Hornsea Project Four

Applicant's Responses to the ExA's Second Written Questions

Deadline 5, Date: 20 June 2022

Document Reference: G5.2

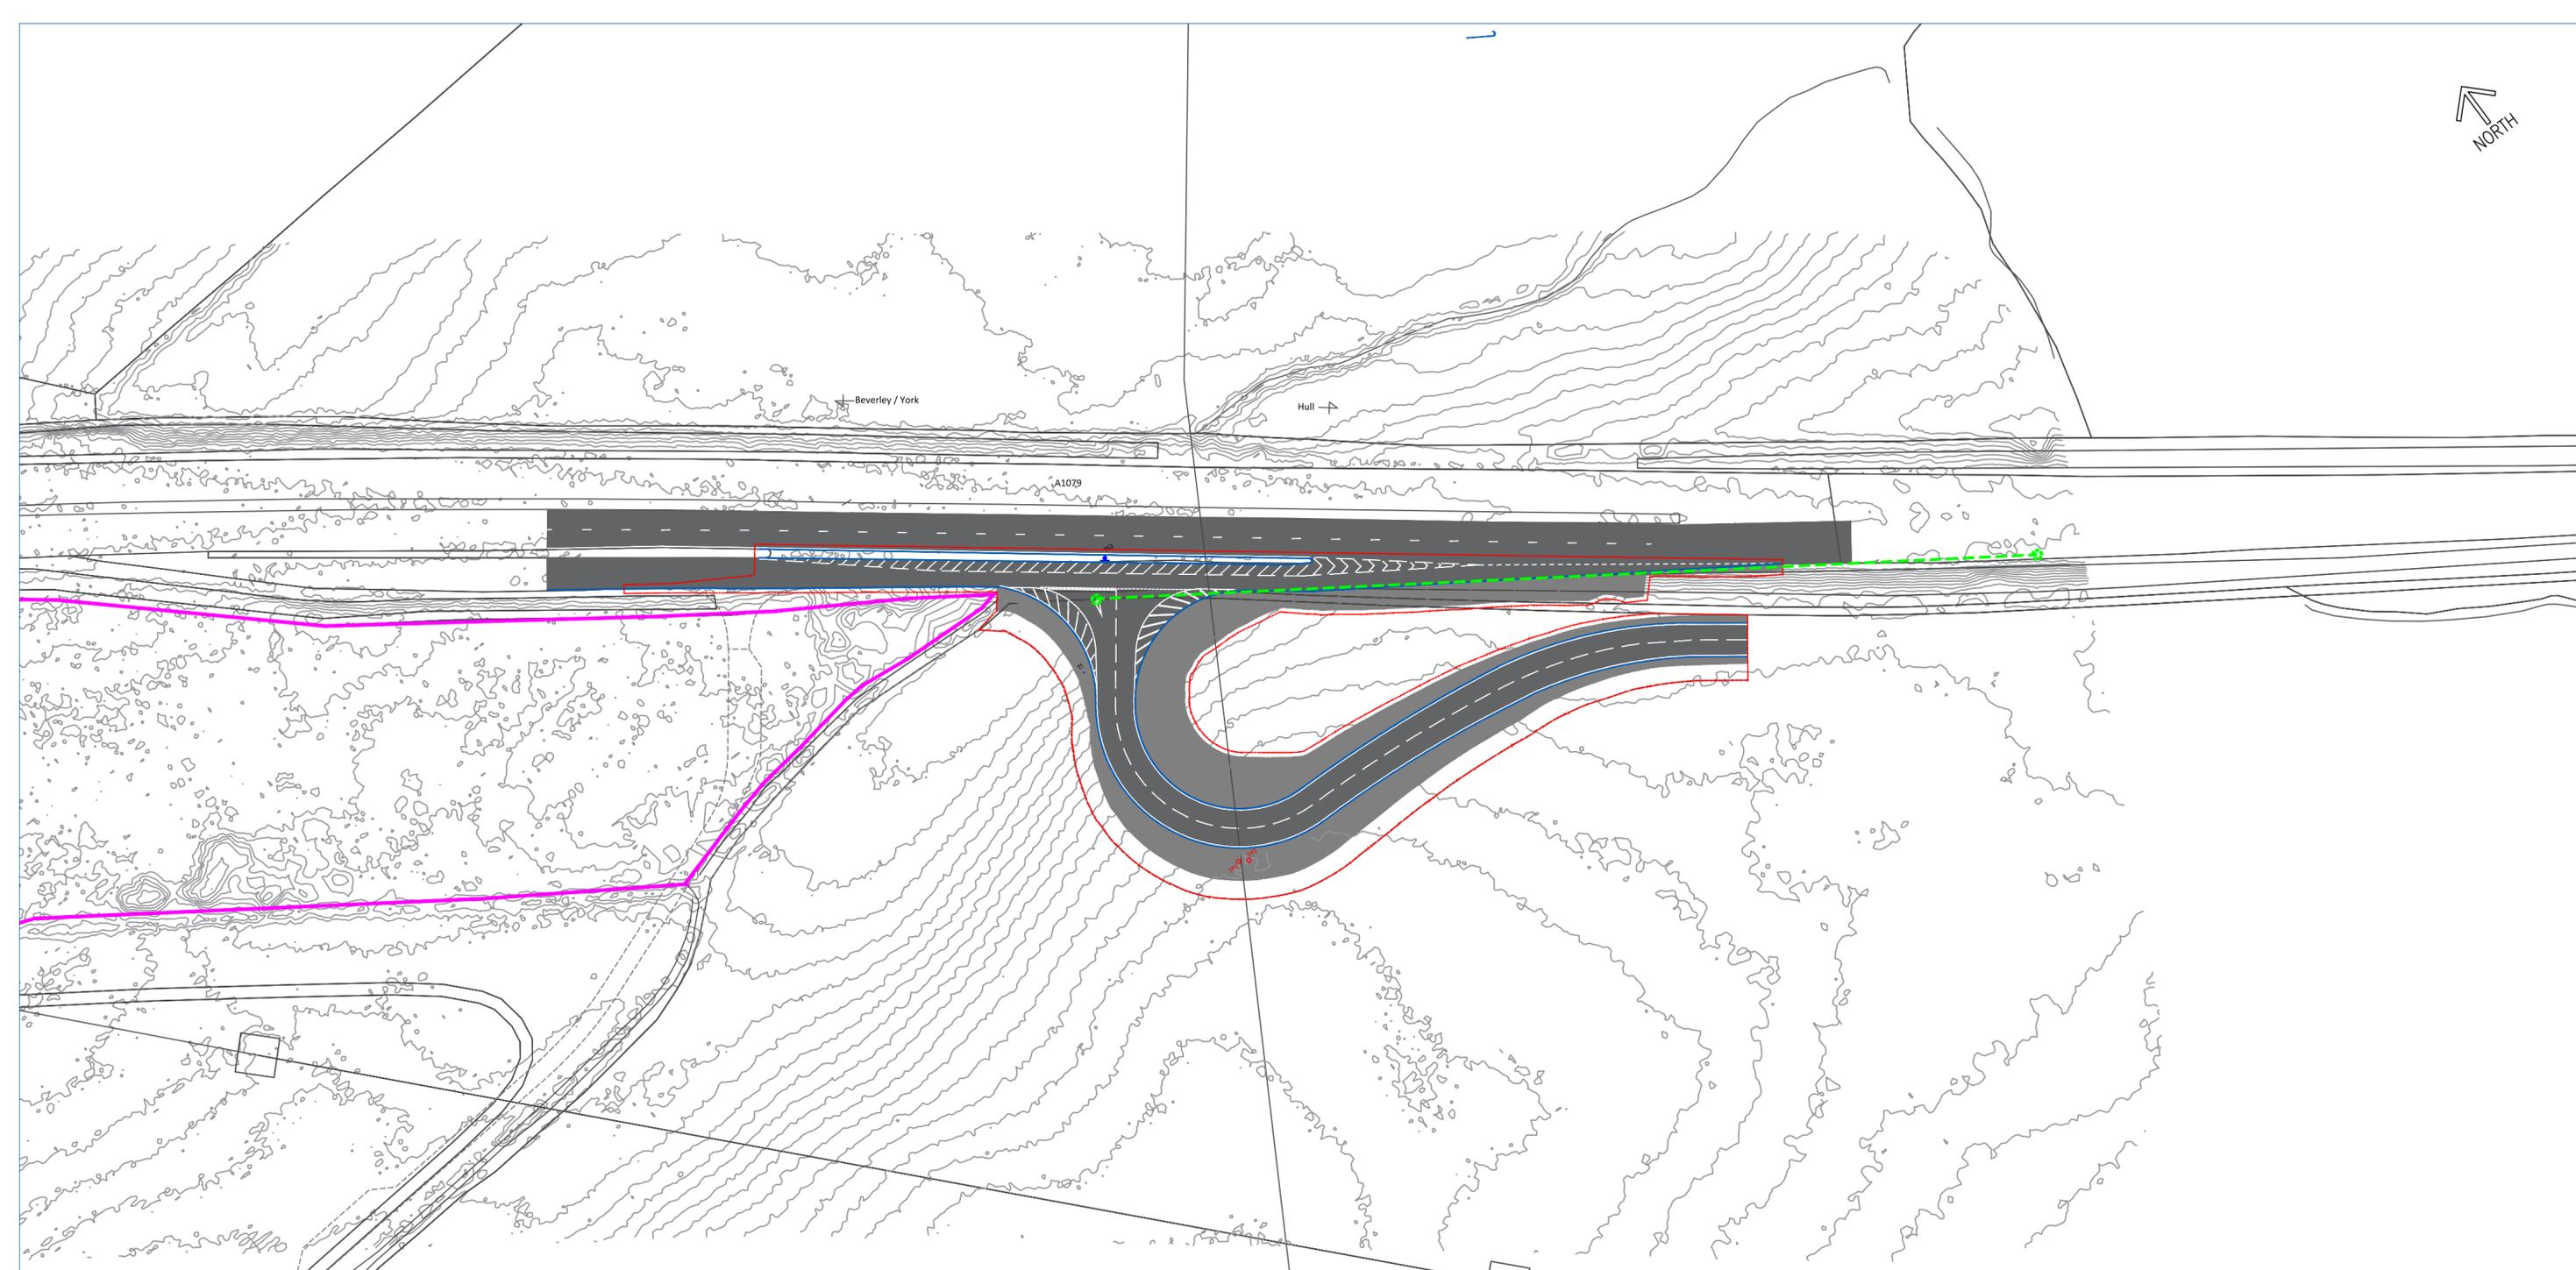
Item	RSA Problem	RSA Recommendation	Design Organisation Response
	Summary: Inadequate geometry at the junction could lead to conflicts between vehicular movements with a potential for collisions between road users.		
7	Location: A1079 northbound layby/ proposed OnSS access. Summary: Insufficient visibility to the right for drivers exiting the OnSS access into the layby could lead to side impact collisions or rear end shunts.	The visibility splay to the right of the OnSS access should be provided as part of the response to this Stage 1 Road Safety Audit. The visibility splay should be commensurate to the observed speeds of vehicles approaching the layby from the A1079.	Accepted: Drawing No. LTP/3505/P4/02/01 provides a visibility assessment for the proposed access indicating that a visibility splay of 2.4m x 215m commensurate with the minimum Sight Stopping Distance for simple priority junction at a 120kph design speed can be accommodated based on the Ordnance Survey digital mapping available. Visibility requirements to be further reviewed and established at the detailed design stage.

8	Location: Proposed OnSS access. Summary: Insufficient signage at the OnSS access could lead to increased vehicle manoeuvres and the potential for collisions within the layby and on the A1079.	Appropriate 'no entry except authorised vehicles' signage should be provided, reducing the potential for unauthorised access and collisions due to increased vehicle manoeuvres.	Accepted. Signing requirements to be considered at the detailed design stage for the scheme.
9	Location: A1079 northbound approach to the layby and new access. Summary: Failure to provide advanced information could lead to sudden braking and rear end shunts on entry to the layby.	Appropriate advanced signage should be provided on approach to the access, reducing the potential for sudden braking and subsequent collisions.	Accepted. Signing requirements to be considered at the detailed design stage for the scheme.
10	Location: A1079, extended kerbed island separating the active carriageway from the layby. Summary: Insufficient conspicuity of the kerbed island could result in vehicle strikes to the kerb, leading to the potential for high speed loss of control collisions with other road users.	A reflective bollard should be provided on the traffic-facing extent of the extended kerbed island.	Accepted. Signing requirements to be considered at the detailed design stage for the scheme.
